Administrative Action
Preliminary Subdivision

Case File / Name: **S-57-07 / Heritage Manor Lot 146**

Nature of Case: This request is to approve the subdivision of a 1.16 acre tract into 3 lots, zoned R-6. The unit per acre density is 2.59. This is not an infill project.

S-57-07 / Heritage Manor Lot 146 – Lot Layout

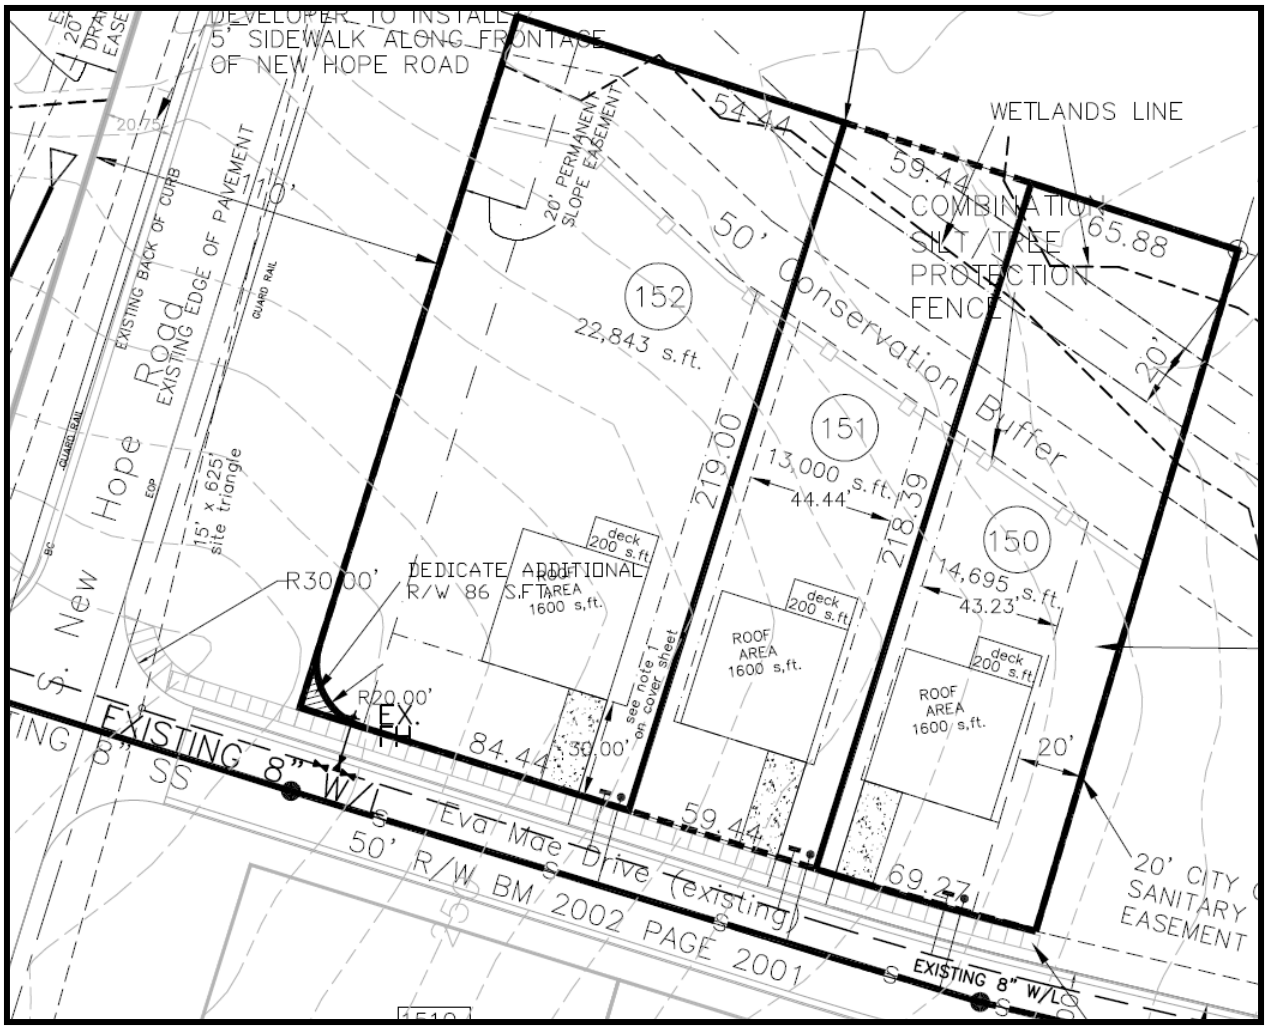
(3) That right-of-way dedication at the intersection of New Hope Rd. and Eva Mae Dr. as shown on the preliminary plan be shown on all plats for recording;

(4) That a 20’ slope easement along New Hope Rd. be shown on all plats for recording;

(7) That the following note be placed on all plats for recording: "Driveway for Lot 152 shall be located within 20' of eastern property line [with Lot 151]";

THOROUGHFARE / COLLECTOR PLAN: This site is required to dedicate right of way at the intersection of Eva Mae Dr. and New Hope Rd. and dedicate a 20’ slope easement along New Hope Rd. No other improvements are required.

PEDESTRIAN: Developer is responsible to install a 5' sidewalk along New Hope Rd.
